CITY OF LA VISTA
MAYOR AND CITY COUNCIL REPORT
AUGUST 1, 2023 AGENDA

Subject:	Type:	Submitted By:
APPLICATION FOR PLANNED UNIT DEV. LOTS 1-3 SOUTHPORT EAST REPLAT FIFTEEN	RESOLUTION ◆ ORDINANCES (2) RECEIVE/FILE	CHRISTOPHER SOLBERG DEPUTY COMMUNITY DEVELOPMENT DIRECTOR

**CITY OF LA VISTA
PLANNING DIVISION
RECOMMENDATION REPORT**

RE: REV Development – PUD, CUP & Replat Applications – Initial Review Letter
Lots 5-6 Southport East

LANDSCAPE PLAN

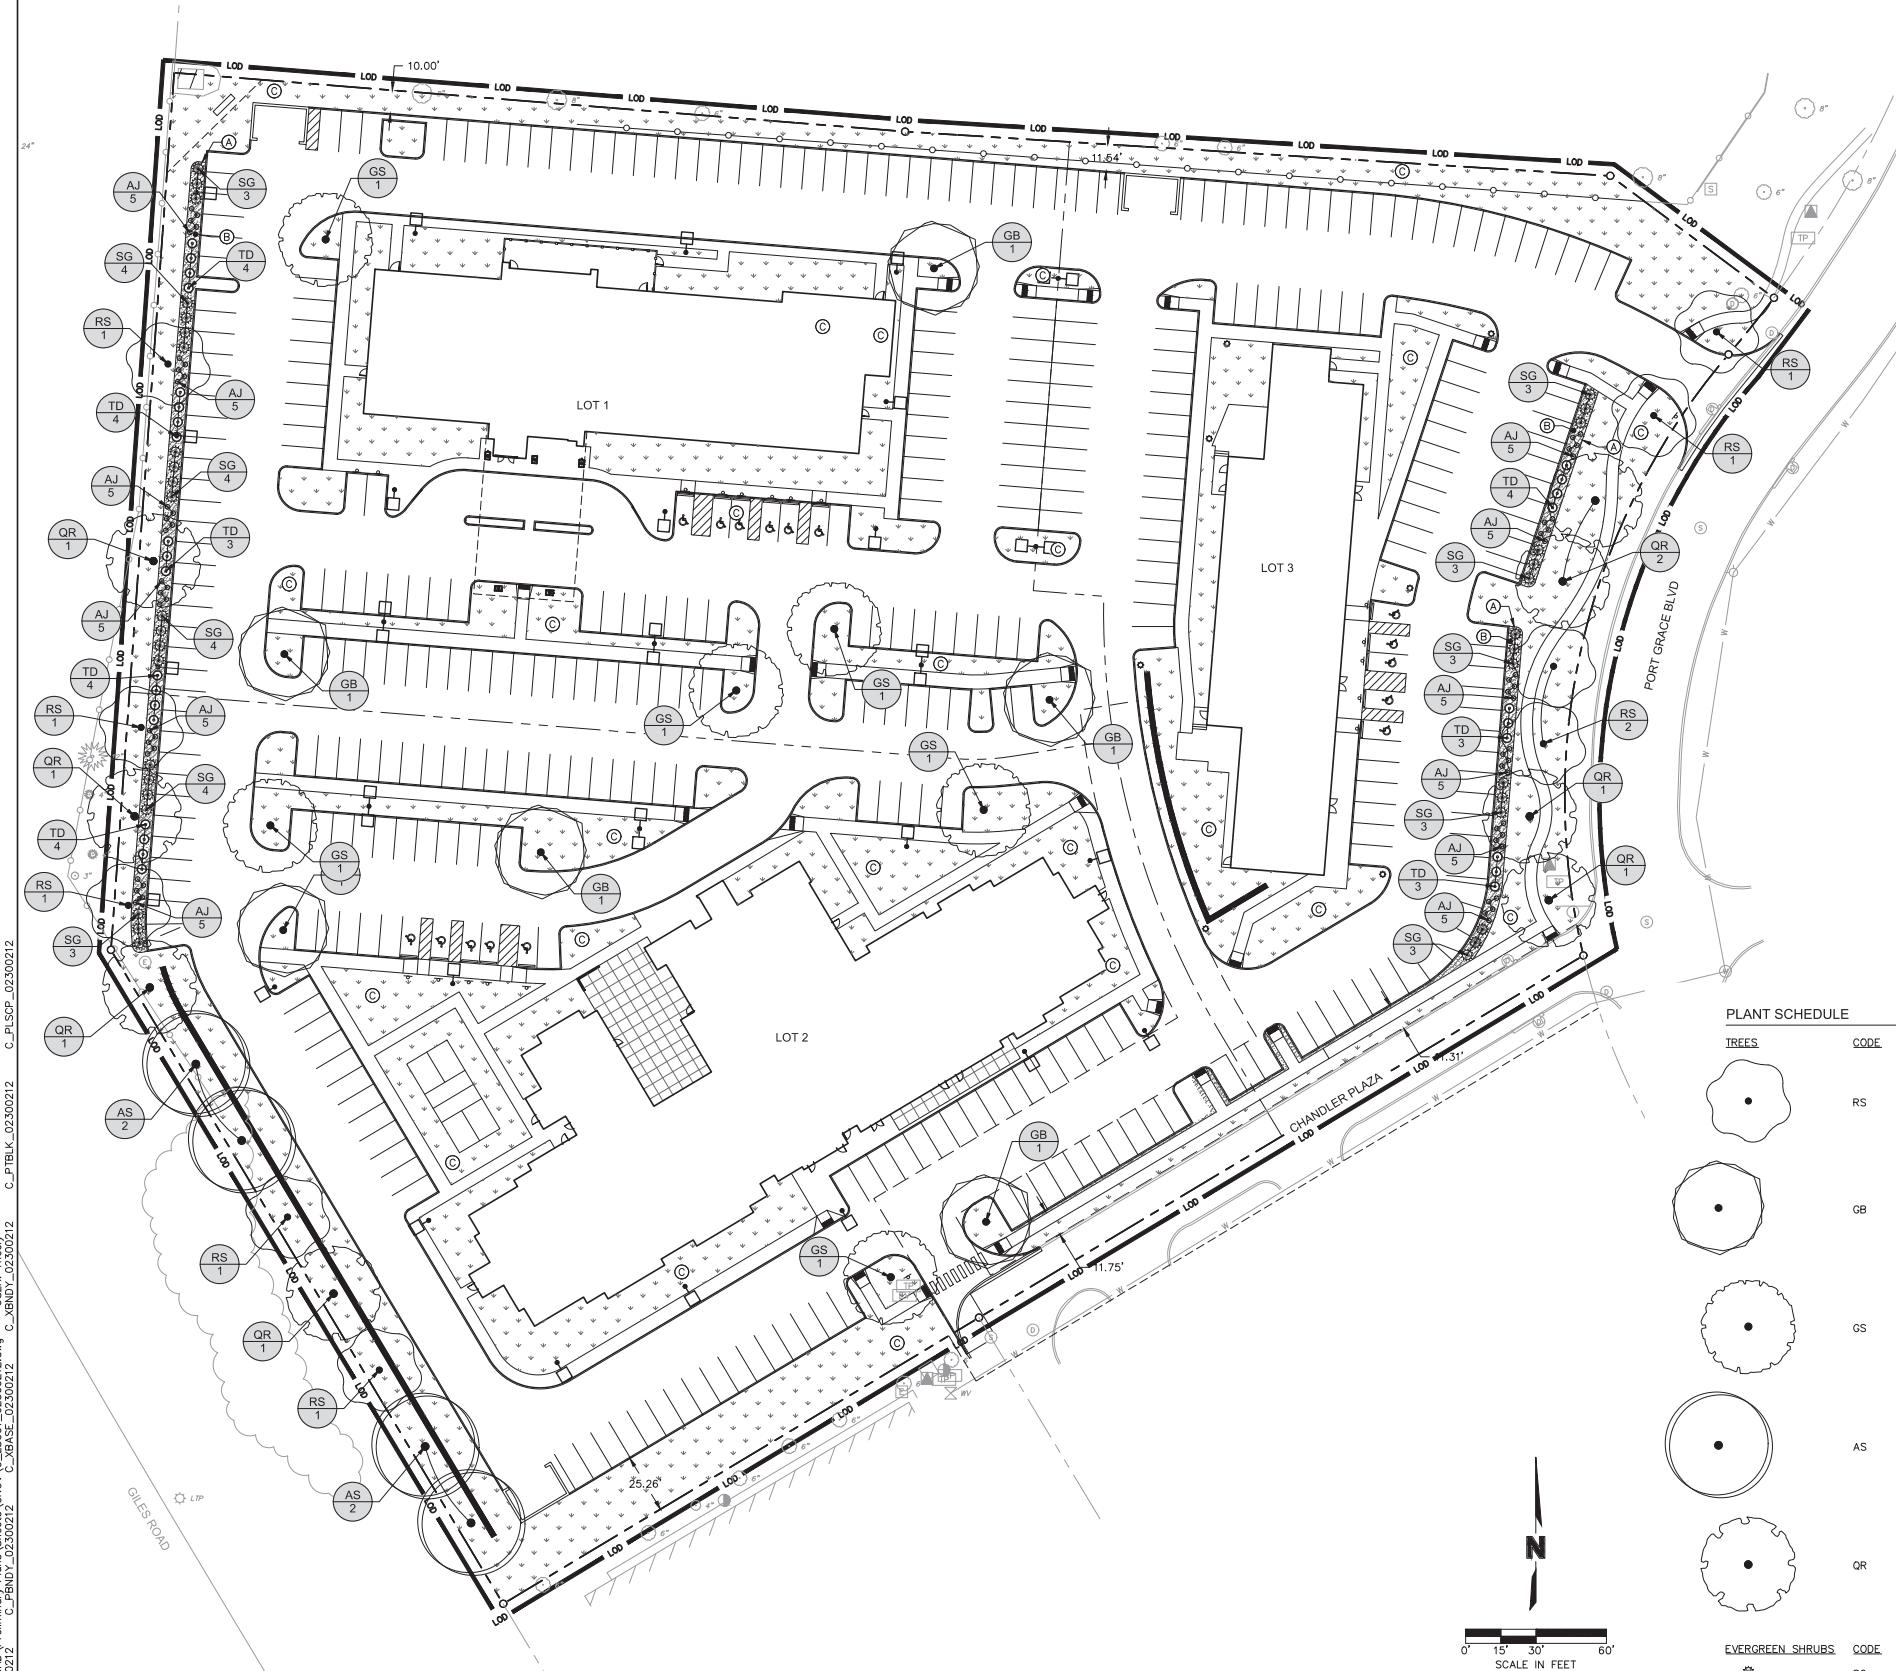
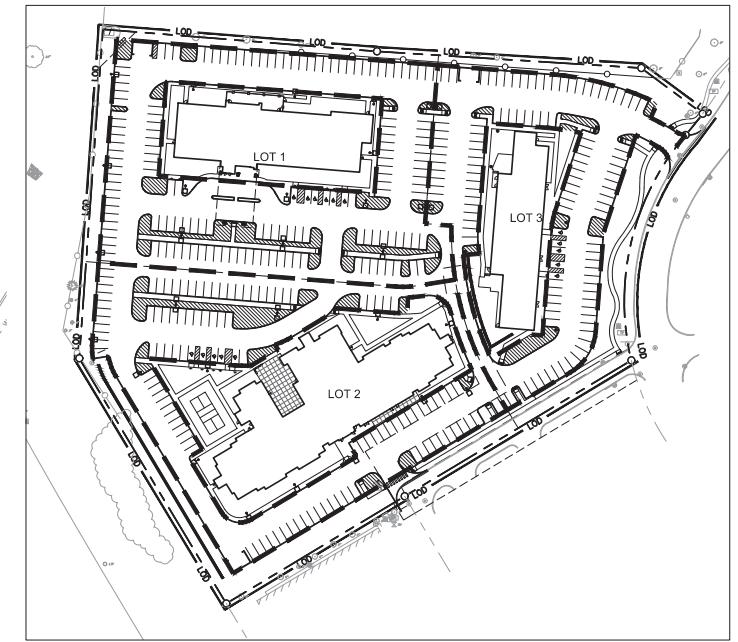
1. Landscaping
 - i. No site dimensions are included to determine compliance with 6.1.D, which requires ten (10) foot wide landscaped, turfed (sodded or seeded) and irrigated green space along all interior lot lines shown in Appendix E.
 - ii. Per appendix G, the following proposed plants are not included in the approved list:
 1. Autumn Blaze Maple
 2. Bloodgood London Plane Tree
 3. Silver Linden
 4. Maney Juniper
 5. Karl Foerster Feather Reed GrassRevise to comply with Appendix G.
 - iii. Per Appendix G, trees shall have a minimum caliper of 3". Trees proposed on plant schedule have a caliper ranging from 2 to 2.5". Revise to comply with Appendix G.
